# Certificate of Appropriateness

1951 N. 2ND ST. James Brandenburg, owner

PTS ID 49178 COA, new side drive in brick

**1951. 2<sup>nd</sup> Street. Brick driveway and concrete approach/apron to be installed according to attached drawings**

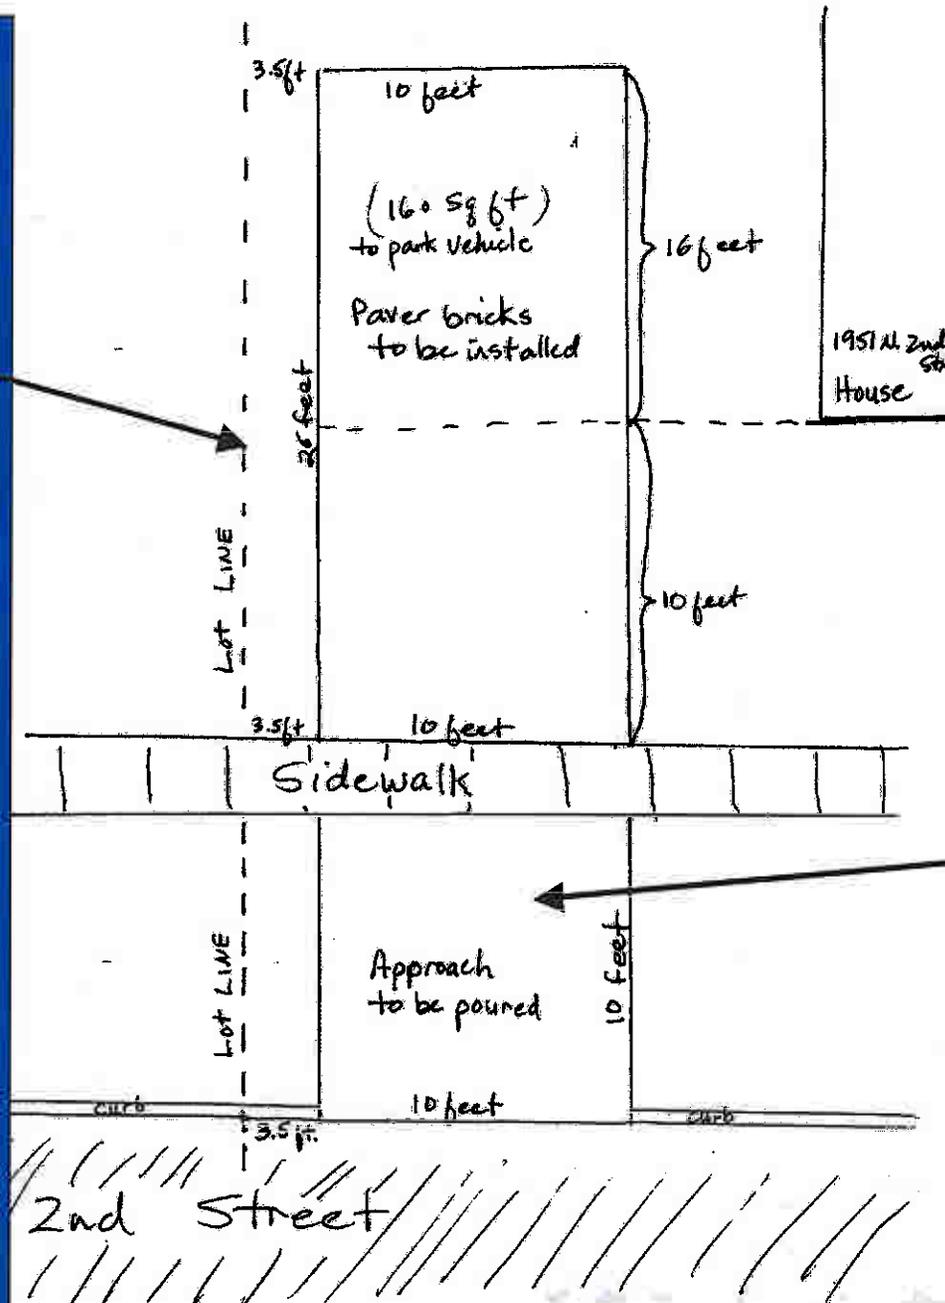
**These paver bricks, already installed will be extended to complete the driveway from the sidewalk to the side yard (see attached plan) Bricks must not be closer than 3.5 feet to the south lot line.**

**Note: brick pavement must be no less than 3.5 feet from the south lot line. Parking is not allowed any closer to the lot line according to the city's zoning code.**

**Concrete apron to be installed by licensed contractors according to specifications and permits from the Dept. of Public works**
